Technical Service BULLETIN

FRONT AXLE HUB NUT REPLACEMENT

'92 – '98 Tercel, Paseo, Corolla, Celica, Camry
'96 – '98 RAV4

DL001-98

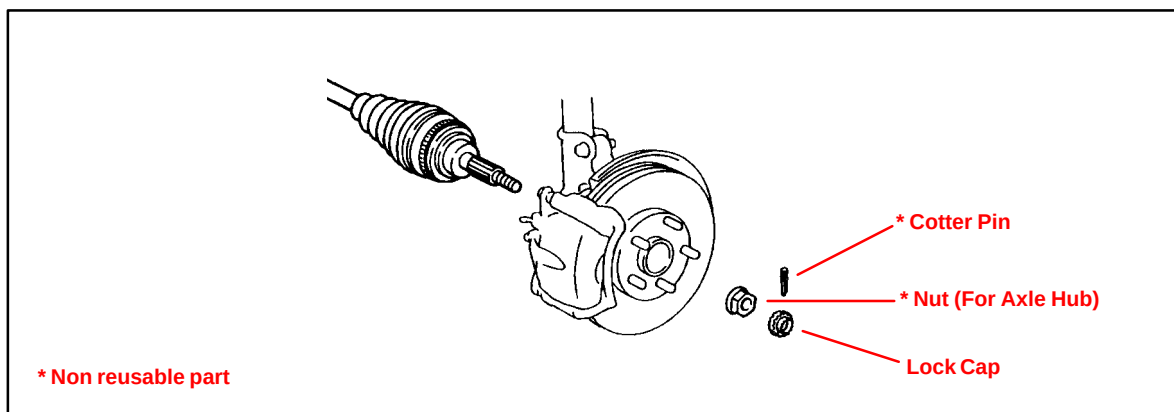
Introduction Due to a change of the friction control treatment on the nut thread, both types of Front Axle Hub Nuts (silver and black) for 1992 – 1998 Tercel, Paseo, Corolla, Celica, Camry and 1996 – 1998 RAV4s are **NOT reusable**.

When replacing the Front Axle Hub Nut the new part must be the same color as the old part. When replacing a Silver nut -- use a NEW Silver nut and when replacing a Black nut -- use a NEW Black nut.

PART NUMBER	PART NAME	COLOR
90179-22020	Nut, Axle Hub	Silver
90178-22001	Nut, Axle Hub	Black
